ST. TAMMANY PARISH

Addendum No.: 1

Bid#: 20-6-2

Project Name: I-10 Service Road Bridge Replacements

Sheet
 22
 Project No.
 Date
 Scale
 Drawn By

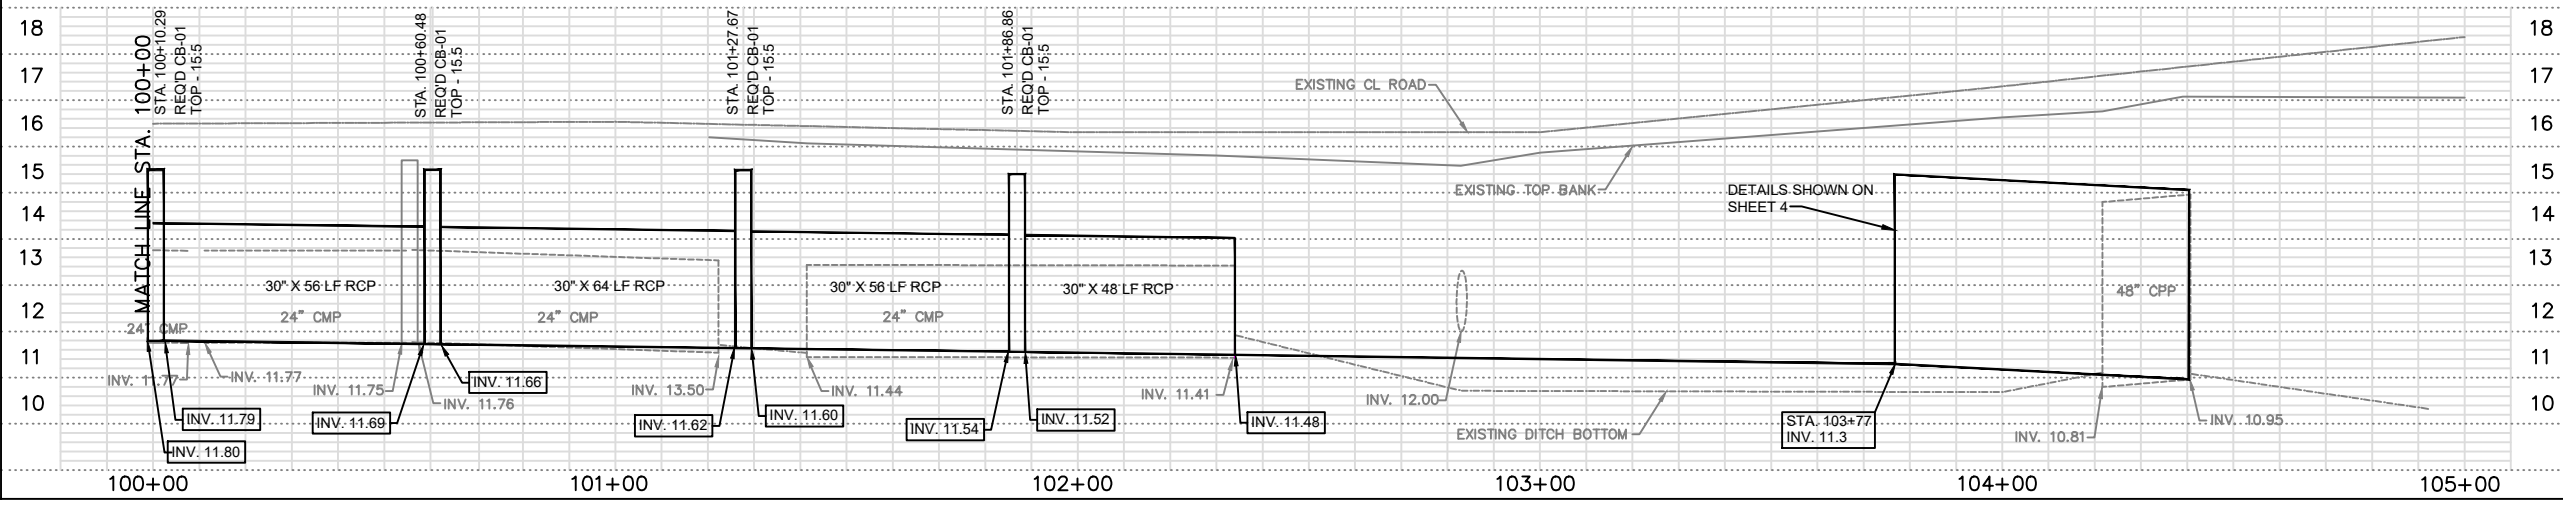
Question 7: The 30" RCPA added to the project in addendum 2 seems to have an incorrect quantity. Adding up the pipe runs on sheets 20-22 comes to a quantity of 1,139 lf. Please advise.

Answer 7: The additional 29 LF of 30" pipe will be used to extend end of the pipe near station 102+50

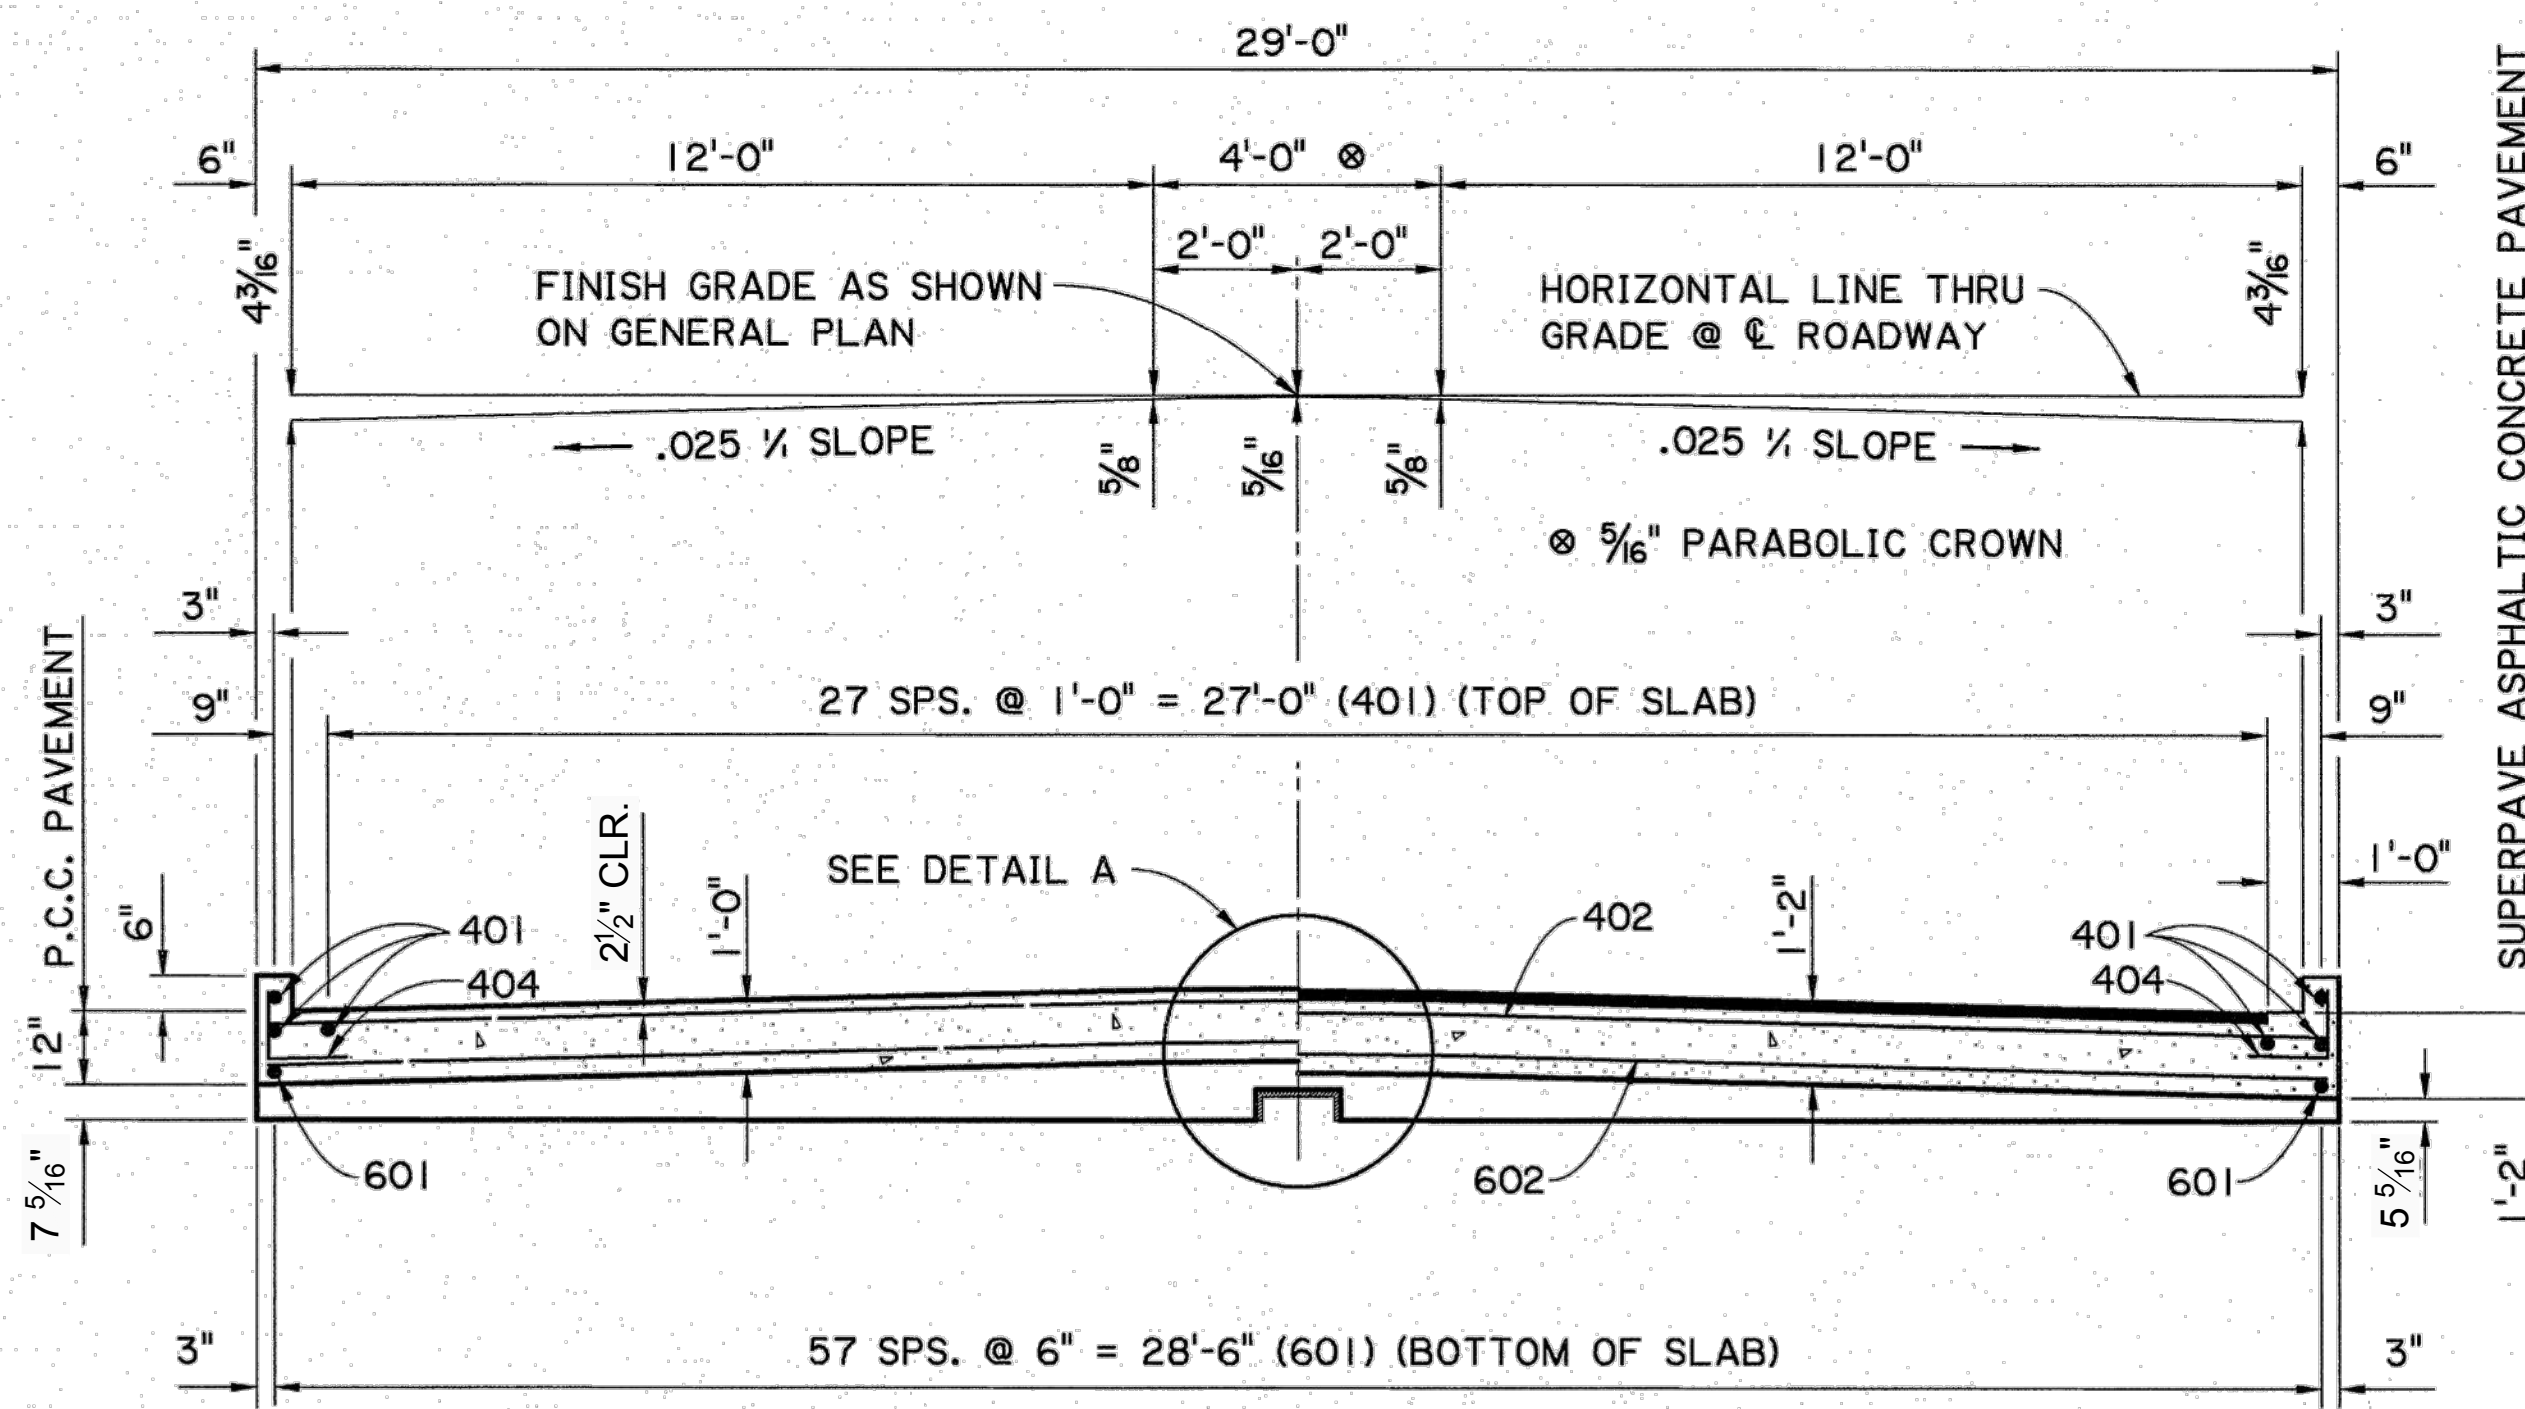
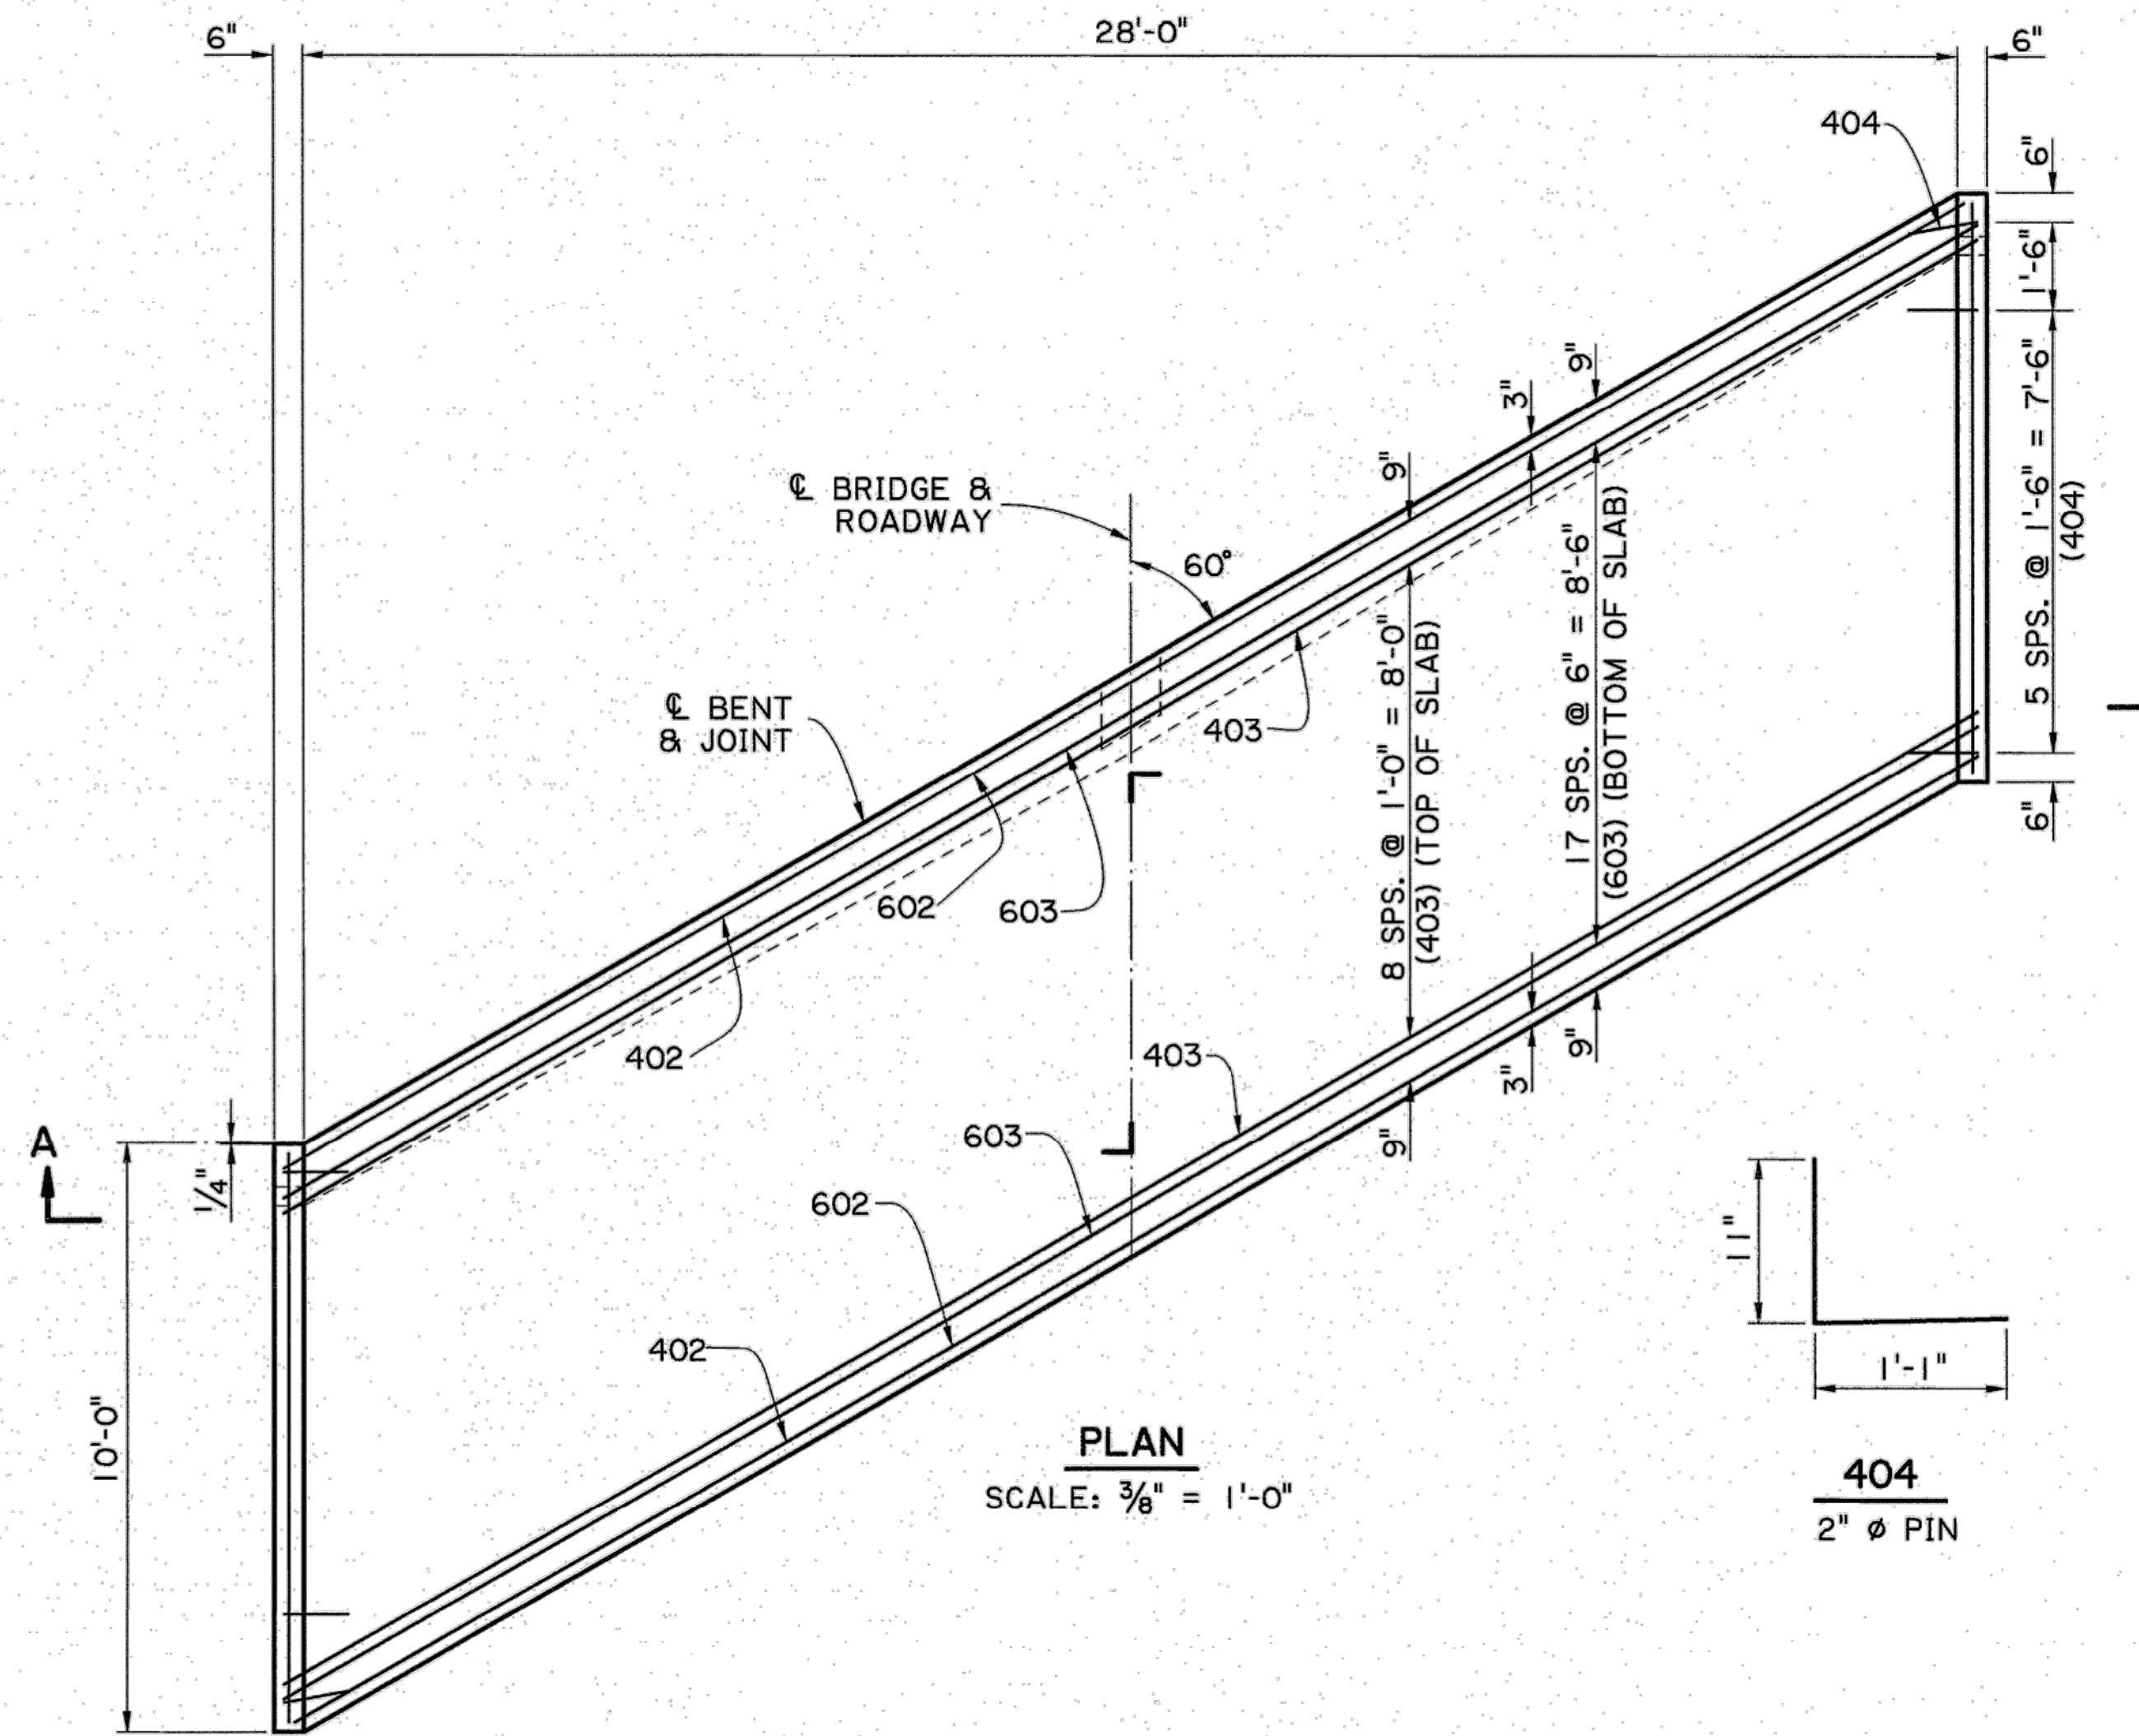
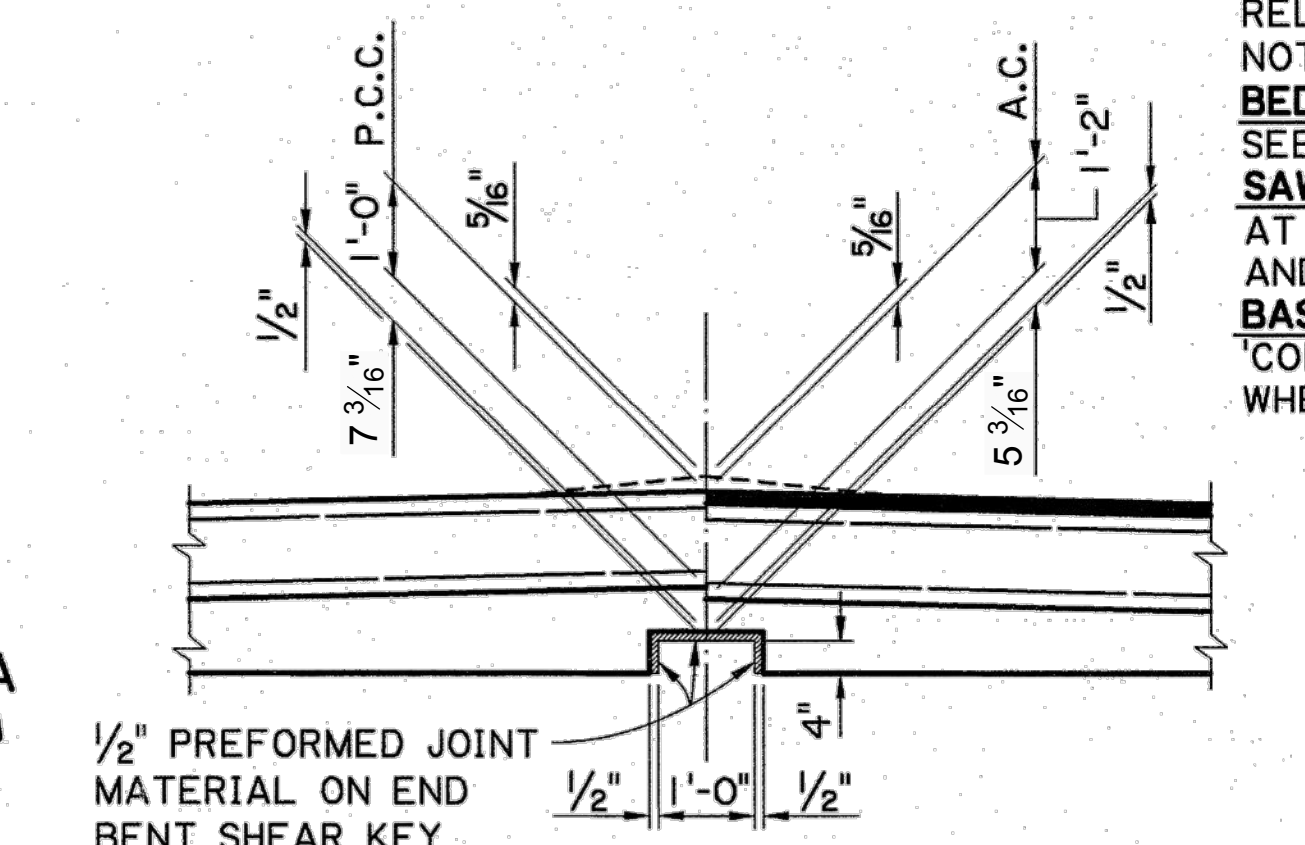
Question 8: This project references 2016 LA DOTD Specs but the approach slab seems to follow the 2006 Specs, will the approach slab require a sleeper slab and bearing pads? Or is it to be as show on plan sheet 106 & 110?

Answer 8: See the attached Plan Sheets 110, 106 and 341 in regards to this question.
